Interactive comment on “Estimating reflectivity values from wind turbines for analyzing the potential impact on weather radar services” by I. Angulo et al.

Interactive comment on Atmos. Meas. Tech. Discuss., 8, 1477, 2015.

Fig. 1.

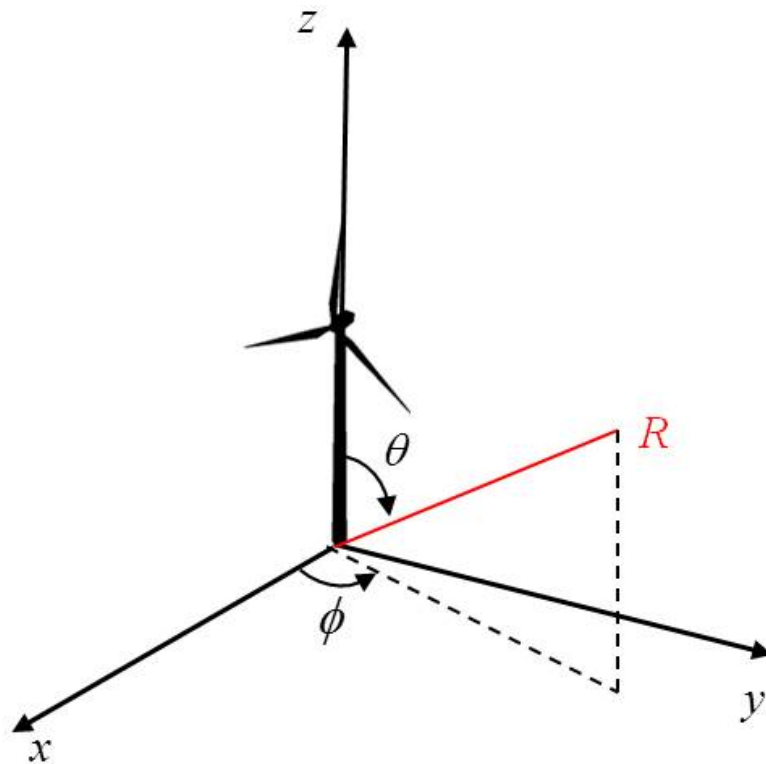
2. Page 1484, Line 23-24 It is not apparent to the reader what the theta and phi parameters represent exactly. It should be clear in Figure 1 what phi represents, and that it is referenced to the normal of the blade face and toward the radar along the radar line of sight (I think?). It would also be useful to define a parameter for the blade

rotation plane, again with explicit descriptions so the reader can visualize easily.

In order to make the coordinate system clearer, Fig. 1 has been simplified. Moreover, theta and phi parameters have been explained in Section 3.1.1, "Simulation tool and wind turbine models", which was Section 3.2.1 before but has been moved to the beginning of Section 3 in order to clarify the coordinate system before explaining the considerations of the analysis (now in Section 3.2). The last paragraph of Section 3.1.1 is now as follows: "Fig. 1 shows the reference coordinate system for the analysis. The wind turbine rotor is supposed to be oriented towards the x-axis and R refers to the radar position. As shown in the figure, θ is the angle from the zenith that defines the radar position in the vertical plane, and ϕ specifies the horizontal position of the radar with respect to the rotor orientation, i.e., with respect to the rotor shaft axis "
